ERRATA

Publisher's Note: “Errata to Optimally Staggered Finned Circular and Elliptic Tubes in Turbulent Forced Convection, 2007, **129**(5), pp. 674–678]” by R. L. S. Mainardes, R. S. Matos, J. V. C. Vargas^{*}, and J. C. Ordonez

Figure 3

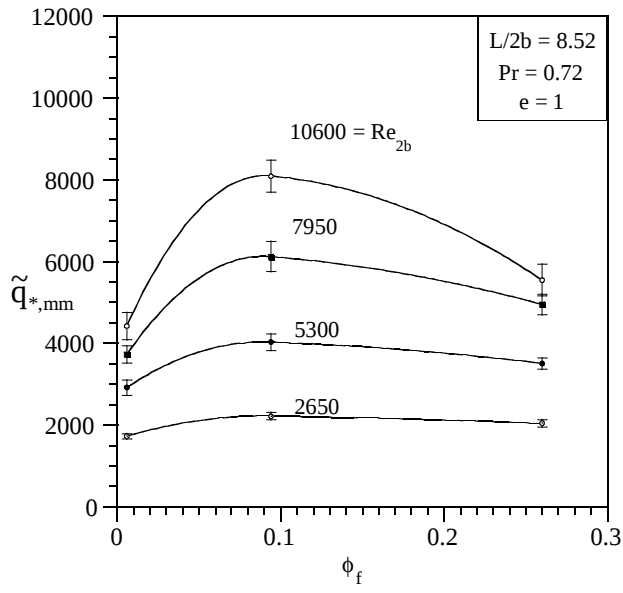
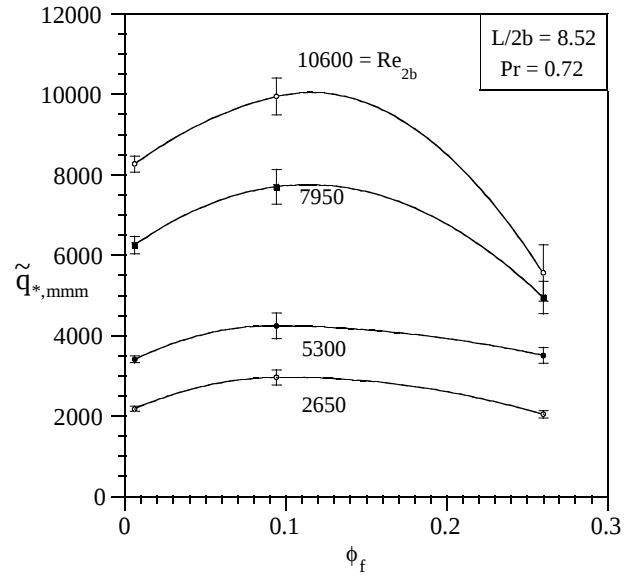
Page 677: replace Figs. 3 and 4 by the corrected ones in the following page:
